# Product Change Notification

**Change Notification #:** 119556-00

**Change Title:** Intel® Server System R2208WF0ZSR,  
PCN 119556-00, Product Design, Label  
Power Supply and Label Update

**Date of Publication:** May 16, 2023

## Power Supply Label

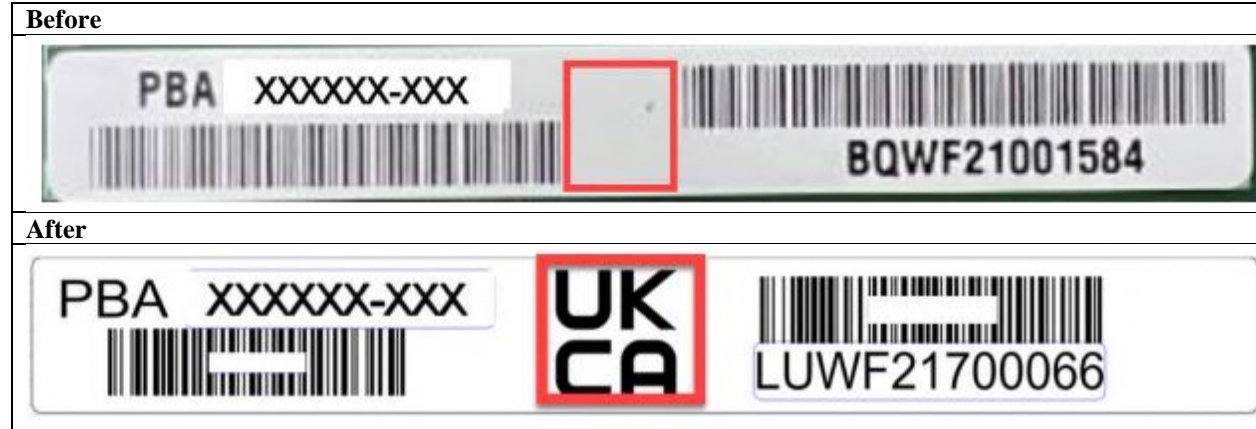
- Adding the UKCA logo in the Server Board Serial Number Label
- The 1300W Power supply is changing from H79286-011 to H79286-012 due to a firmware upgrade from 26.5.128 to 29.5.128 and a minor hardware change, there is no impact on functionality
